**SUBJECT: DEPARTMENT OF THE ARMY PERMIT Number NAN-2012-00090**  
Originally Issued to New York State Thruway Authority on 25 April 2013 Authorizing Regulated Work to Facilitate Construction of The New NY Bridge in the Hudson River between Tarrytown and Nyack, New York

**SUBJECT: Modification to Department of the Army Permit Number NAN-2012-00090 Issued to the New York State Thruway Authority (New NY Bridge Project)**

7. This modified permit shall be known as Permit Number NAN-2012-00090-M7.

Re: The New NY Bridge - DEC Permit 3-9903-00043/00012  
**Permit Modification / Stage 2 Dredging/Mound #3 Removal**

NAN-2012-00090-M7

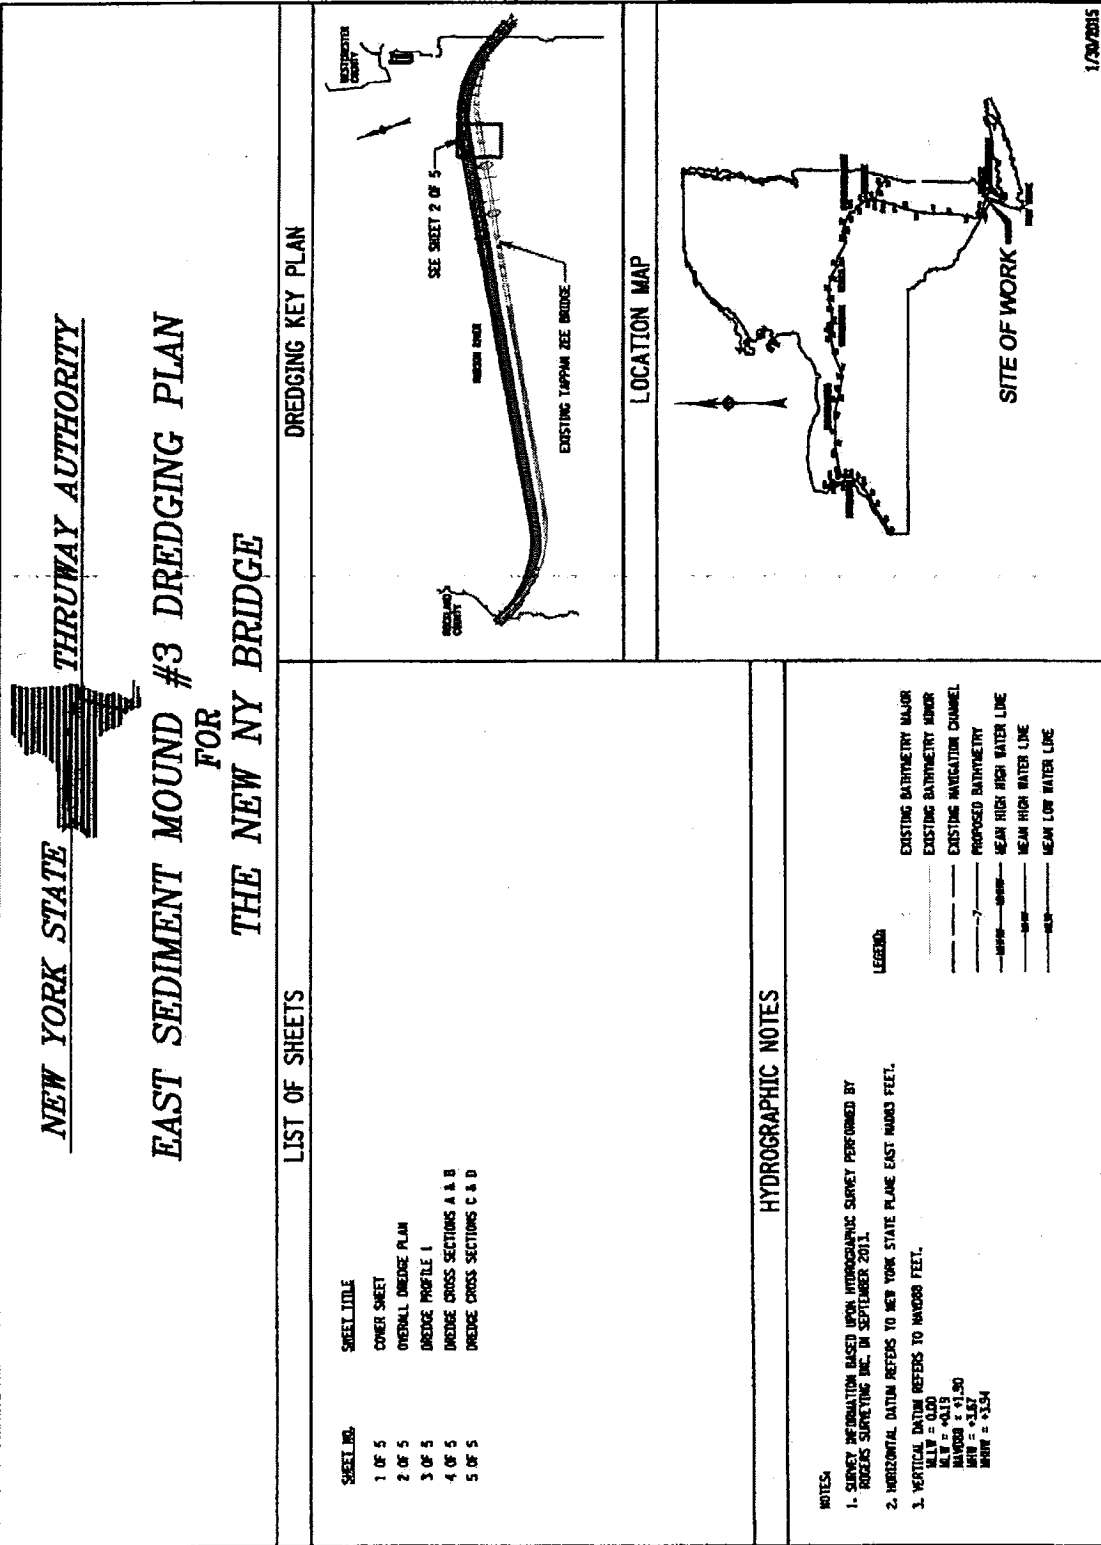
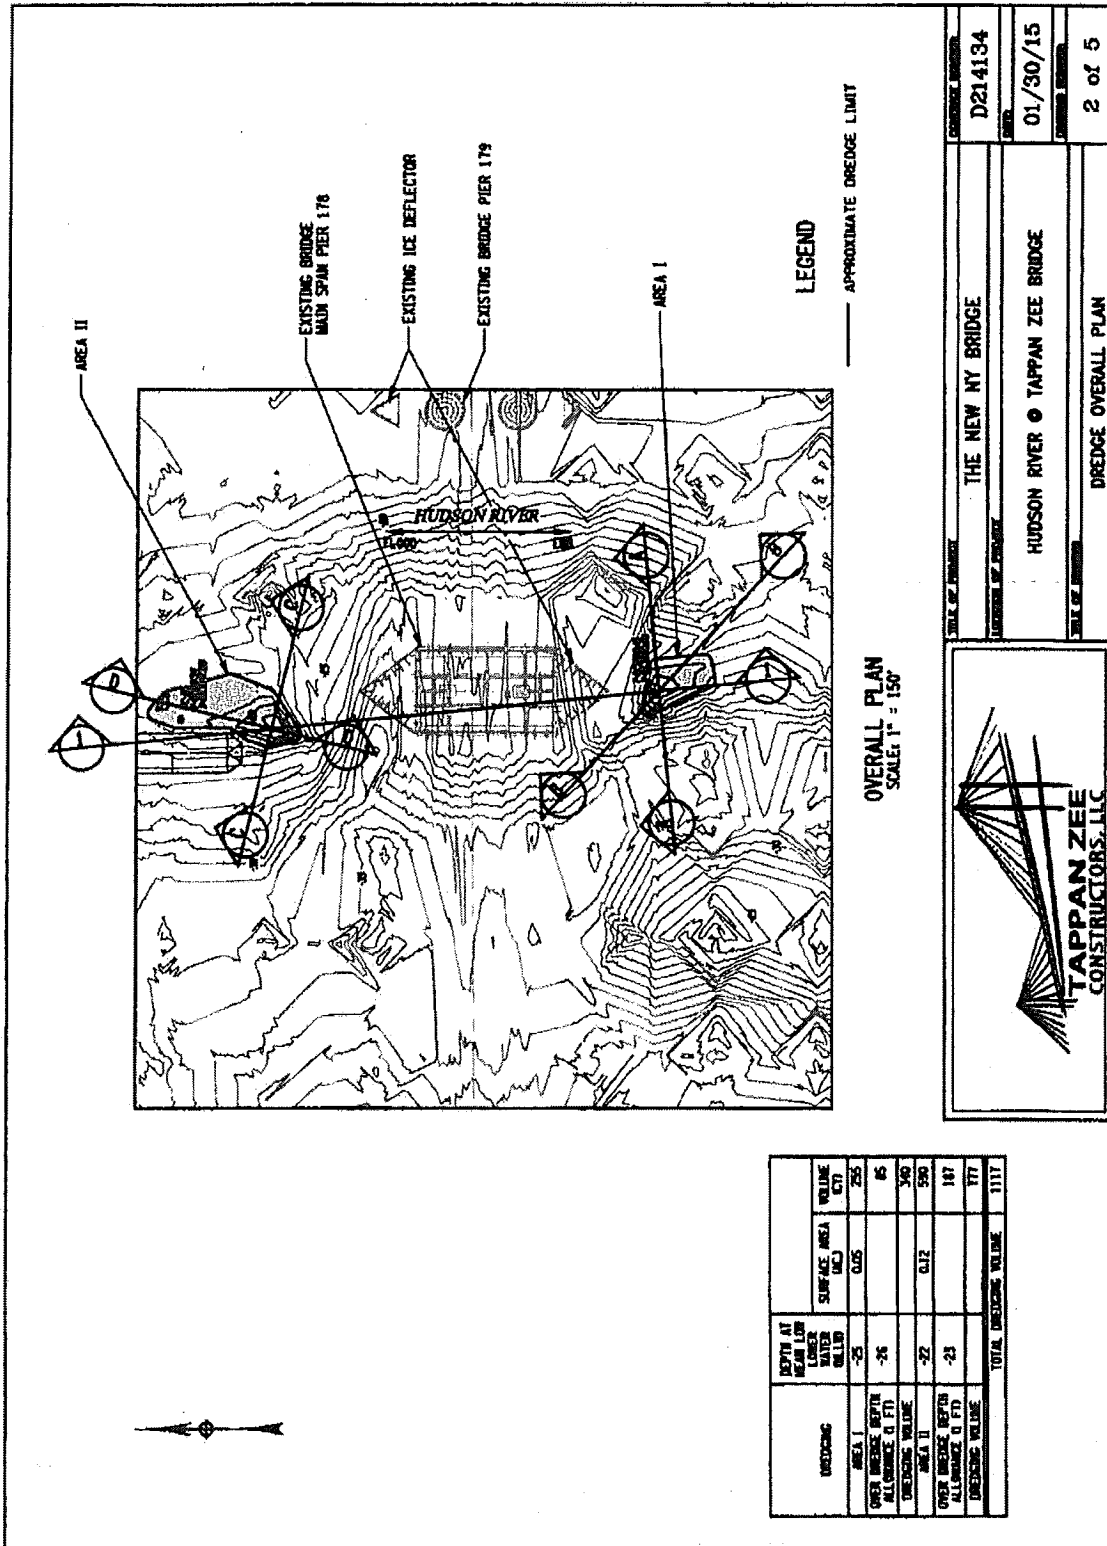
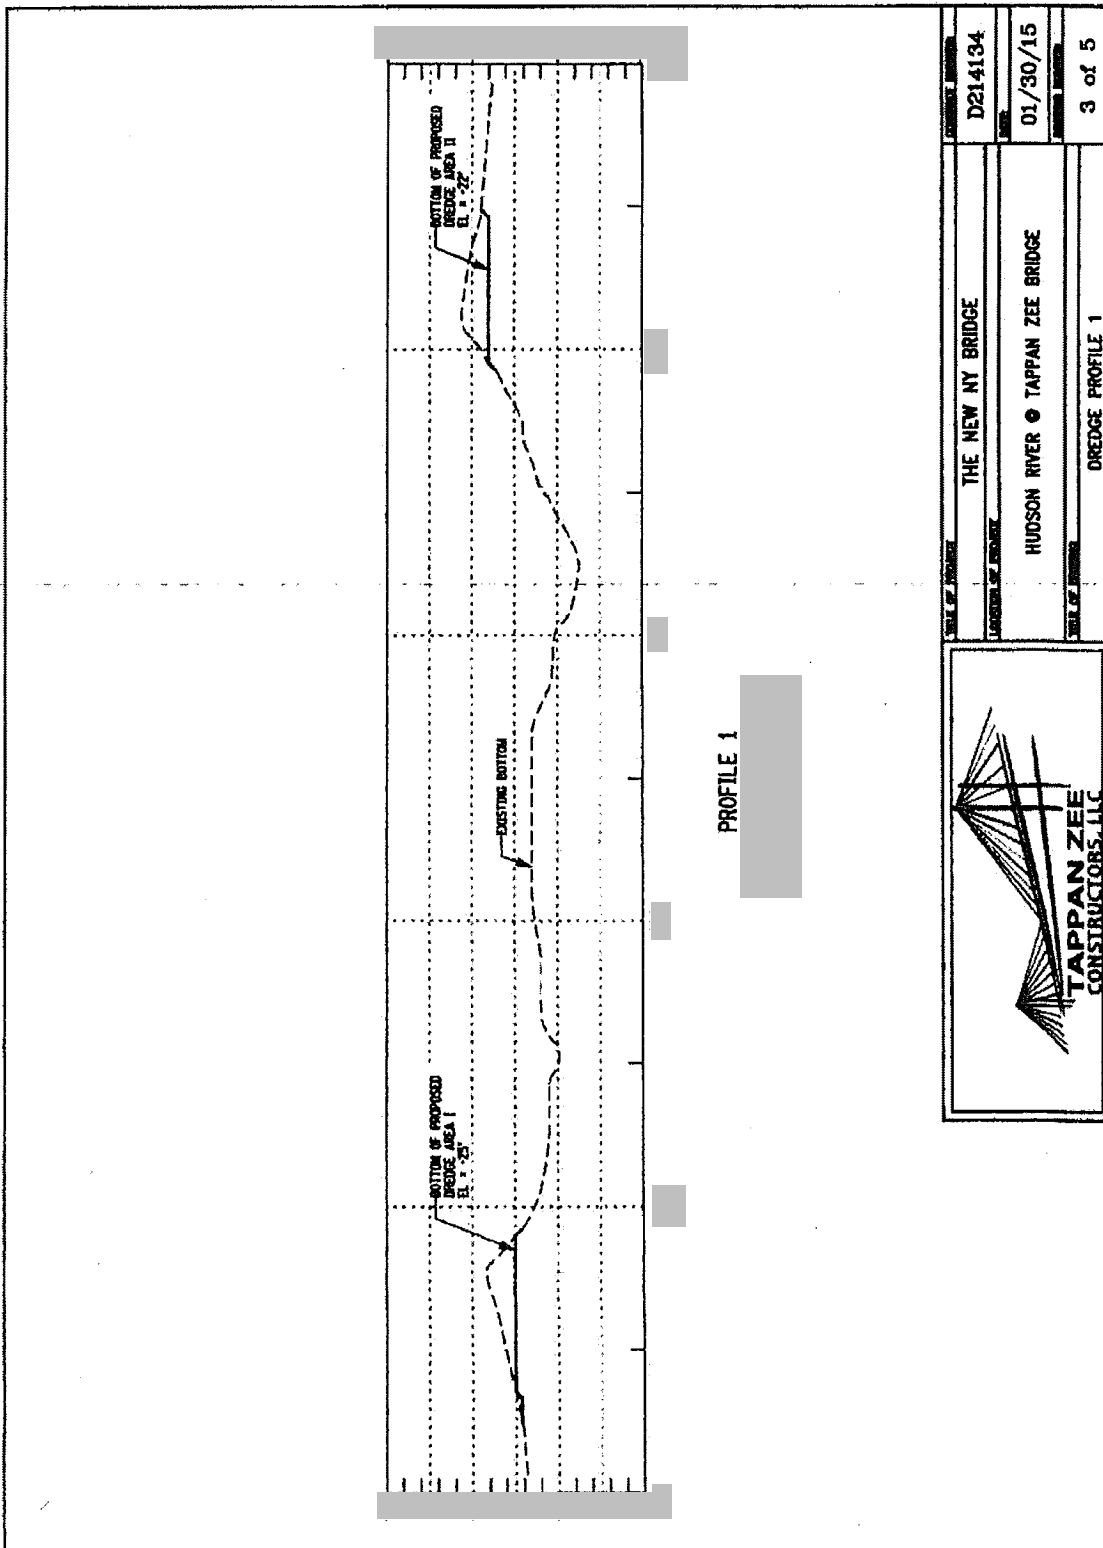
3. The modified regulated work requested at this time includes the dredging a total of approximately 187,960 cubic yards (CY) at a maximum depth of 13-feet (ft) below the plane of mean lower low water (MLLW) plus 1-ft overdredge, and the placement of 2-ft of sand and gravel, a total of approximately 37,960 cy, in the access channel of the Stage 2 Area. In addition, NYSTA has requested DA authorization to dredge the top 3-ft of East Sediment Mound #3 near the existing Tappan Zee bridge.

The work would involve dredging via closed-clamshell bucket of approximately 165,360 CY of sediment from the Stage 2 Area and approximately 22,600 CY from the Access Area to a depth of 13-ft below the plane of MLLW, plus an allowable 1-ft overdredge, for a total maximum depth of 14-ft. The total volume of the proposed Stage 2 Area plus the Access Area dredging is approximately 187,960 CY. The proposed dredging operation would be completed by two dredges over 75 days, for a total volume of approximately 2,500 CY per day.

Once the Stage 2 Area dredging is complete and to prepare a uniform bottom surface in this dredged area, a specific-use drag barge would drag a 35-ton steel beam filled with concrete or "drag bar" across the entire dredge footprint. Approximately two-feet of sand and gravel (armoring), a total of 37,960 CY, would be placed over approximately 12.48 acres within the access channel to limit the re-suspension of sediment due to potential scour from tugs. The sand and gravel would be delivered by barges or scows, and would be placed by barge-mounted cranes. Without the armoring, additional dredging would be required to create a deeper work zone. Bed leveling would be conducted simultaneously with the placement of the armoring material.

The Access Area would remain unarmored, providing a design channel depth of 13-ft, plus 1-ft overdredge, for a total depth of 14-ft below the plane of MLLW, to accommodate the LCL draft requirements during heavy lifting operations. It is anticipated that approximately three to four lifting operations would be required to remove that portion of the existing bridge spanning the Metro-North Railroad ROW. Shallow-draft tugs would slowly move the LCL into position for removing and placing portions of the existing bridge onto attendant barges, minimizing re-suspension of sediment.

5. Based upon an evaluation of the administrative record supporting the issuance of the subject permit, a review of the permittee's submitted materials in support of their permit modification request [Reference 1(h)], and the incorporation of the aforementioned special condition, the subject permit is hereby modified to include the previously described proposed activities; the engineering plans titled "New York State Thruway Authority, Stage II Dredging Permitting Plan for The New NY Bridge", dated 16 April 2014, Sheet Numbers 1 to 10, and the engineering plans titled "New York State Thruway Authority, East Sediment Mound #3 Dredging Plan for The New NY Bridge", dated 30 January 2015, Sheet Numbers 1 to 5, are included as part of the previously authorized permit drawings.
